Memorandum

Date: 3 August 2020
To: Michael Bowen, California State Coastal Conservancy
From: Jacob Krall, Project Engineer
Rob Annear, Senior Principal
Anju Wicke, Senior Principal
Subject: Review of Conceptual Approach to Scott Dam Removal and Sediment Management
Geosyntec Project Number: WR2851

REVIEW OF CONCEPTUAL APPROACH TO SCOTT DAM REMOVAL AND SEDIMENT MANAGEMENT

Figure 1. Map of Lake Pillsbury showing tributaries. Taken from McBain (2019).

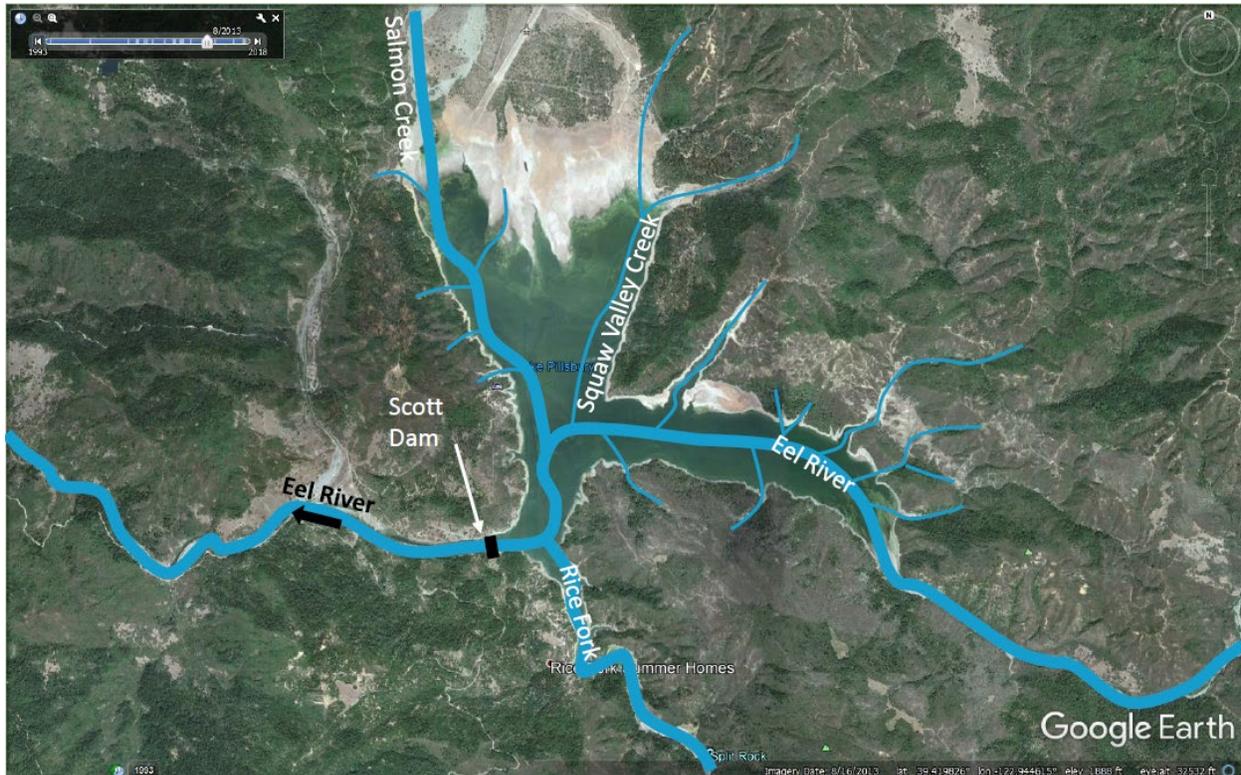
The presentation focuses on the width of the impoundment relative to the width of the channel and the depth of the trapped sediments. Other characteristics that have been shown to be important in determining the fate of trapped sediments following dam removals, including the cohesion of the trapped sediments, and the volume of trapped sediments relative to the sediment transport in a typical year, were not evaluated. The presentation specifically drew lessons from the dam removal as they apply to the mainstem Eel River, Salmon Creek and Rice Fork. Figure 1 shows a map of these tributaries from McBain (2019). Each tributary is discussed separately below.

The Eel River mainstem is a wide impoundment with sediment depths much greater than the bankfull channel depth. The McBain presentation equates this scenario to the Glines Canyon Dam on the Elwha River in Washington State. The presentation notes that a significant percentage of the impounded sediments were mobilized downstream through a process where the channel downcuts into the trapped sediments and creates a wide meander belt through the former impoundment.

The Rice Fork arm has a narrow, confined impoundment approximately equal in width to the channel. The McBain presentation draws lessons for this case from the Condit Dam on the White Salmon River in Washington State. The presentation says that these scenarios often transport 100% of their impounded sediments. Our understating is that approximately 70% of the impounded sediments were mobilized in the first year following the removal of the Condit Dam. Furthermore,

there are cases where a narrow impoundment has had as low as 30% of its impounded sediments mobilized. So, while the Rice Fork does have a key characteristic—a narrow impoundment—that is consistent with rapid erosion of the majority of trapped sediments, it also has cohesive sediments (12.7% clay and 65.8% silt based on Geosyntec Consultants, Inc. [Geosyntec], 2020) and it is uncertain that a staged removal of the dam would yield to rapid full mobilization.

Salmon Creek, part of the North Arm of Lake Pillsbury which also includes Squaw Valley Creek, is a wide impoundment relative to the channel and has shallow sediment depth. The McBain presentation draws lessons for this scenario from the removal of the Tannery Brook Dam in New Hampshire. In the case of Tannery Brook, most of the impounded sediment did not mobilize. This is consistent with the dam removal literature for this type of impoundment.

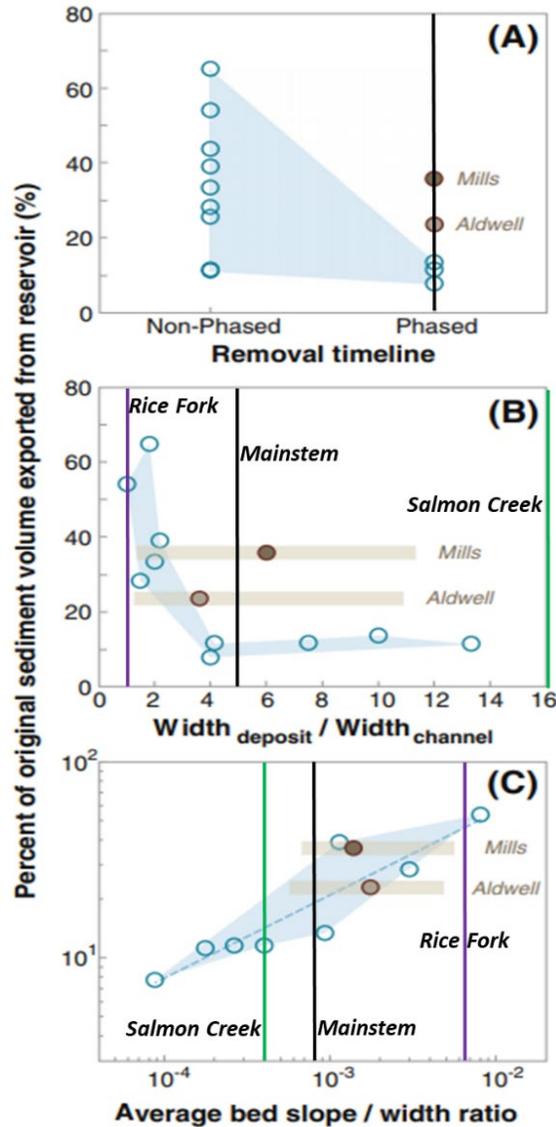
It is instructive to plot Eel River, Rice Fork, and Salmon Creek on several plots obtained from syntheses of dam removal literature. Figure 2 is a figure reproduced from Warrick et al. (2015) with lines indicating Eel River, Rice Fork, and Salmon Creek. The figure indicates that past phased removals have exported 10-40% of the impounded sediment (a). The second panel shows that the ratio of width of the deposit to width of the channel has been important in past removals (b), suggesting that 50-70% of the impounded sediment at the Rice Fork would be expected to be exported, compared with approximately 10% for the mainstem Eel River and approximately 10-20% for Salmon Creek/North Arm. The third panel (c) finds a relationship between the ratio of average bed slope to the width ratio plotted in (b) and the fraction eroded; this relationship would predict approximately 70% erosion efficiency for Rice Fork, 10-40% for the mainstem, and approximately 10% for Salmon Creek/North Arm. This compares with the estimated 55-59% estimated removal based on McBain (2020) and is consistent with the McBain work being an upper bound estimate on the post-removal erosion.

Figure 3. Modified from Major et al. (2017). Scatterplot of V^* and E^* (defined above) as a function of sediment volume stored in the reservoir.

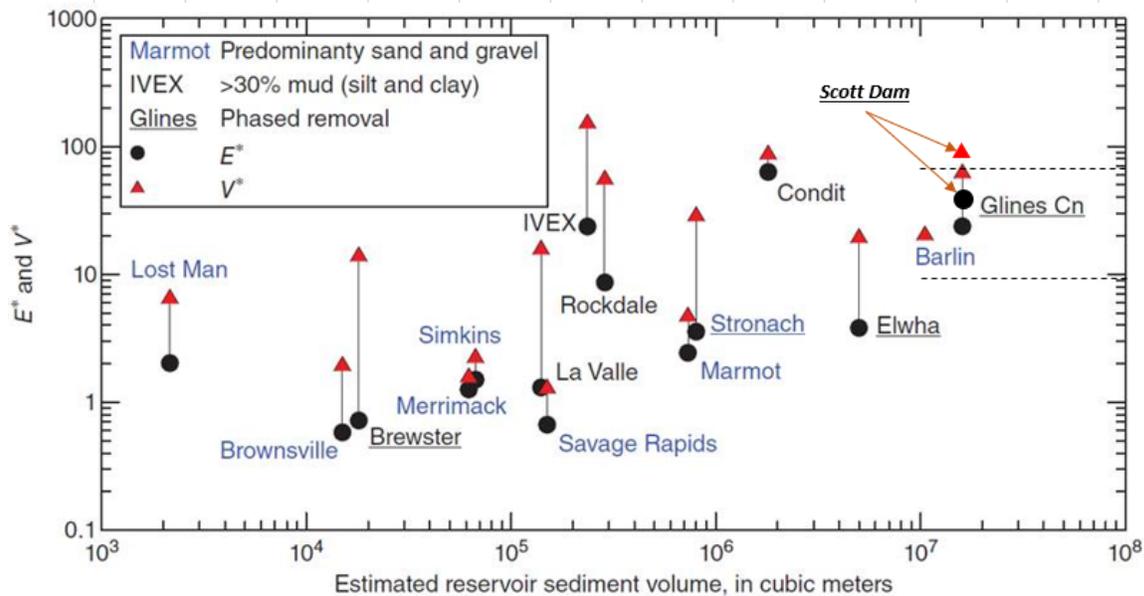
Figure 3 shows another scatterplot comparing past dam removals, modified from Major et al. (2017). The x-axis represents the amount of sediment trapped behind the dam and the y-axis represents two different dimensionless ratios:

- V^* is the ratio of reservoir sediment volume to estimated volume of sediment transported in a year (annual sediment load). For Scott Dam, the annual sediment load was estimated by taking the approximate annual sediment deposited per year, estimated to be 226,000 cy (the average of the two estimates calculated using the McBain volume estimates) and adjusting by assuming a 94% trap efficiency. A 94% trap efficiency is a reasonable estimate based on Porterfield and Dunnam (1964) but possibly too high since the amount of fine sediment passing by the dam is unknown. Using these two assumptions, the estimated annual sediment load is 240,000 cy per year. Dividing the average of the reservoir sediment volume estimates (21.2 million cy) by the estimated annual sediment load results in an estimated V^* value of 88 for Scott Dam.

- E^* is equal to V^* multiplied by the fraction of reservoir sediment that is eroded during the first year following dam removal. Dotted lines are shown representing removal fractions of 10% and 60% and a black dot representing Scott Dam is shown at the average value of 35%: $E^* = V^* \times 0.35 = 88 \times 0.35 = 31$.

Important observations from Figure 3 relevant to Scott Dam and Lake Pillsbury include:

- The higher estimate of sediment volume trapped behind Scott Dam (22 million cy or 16.8 million cubic meters) is higher than the estimated sediment volume for any dam removal in the Major et al. dataset, slightly higher than for the Glines Canyon Dam.

- For some past dam removals, e.g., the Condit Dam, E^* and V^* are relatively similar, meaning that a substantial percentage of the stored sediment is mobilized in the first year. However, for the two phased removals of dams with >30% silt and clay in the impoundment, E^* is just 7% (Brewster) and 33% (Glines Canyon) of V^* , meaning that much of the trapped sediment is not mobilized, at least in the first year.

- The two dashed black lines representing 10% and 60% removal of impounded sediment in the first year represent a range of 2.05 to 13.2 million cy of sediment transport in the first year when also considering the range of trapped sediment estimates from McBain.

- While there is substantial uncertainty regarding the fraction of the sediments that will be mobilized following dam removal, the high V^* value means that there is a large amount of sediment stored behind the dam relative to the annual sediment load. This means that there is substantial potential for downstream impacts in the short-term and medium-term (e.g., turbidity increases, aggradation of the channel, etc.) Sediment transport modeling will be critical to understand the extent and implications of these downstream effects and the ability of a phased removal approach to mitigate these impacts.
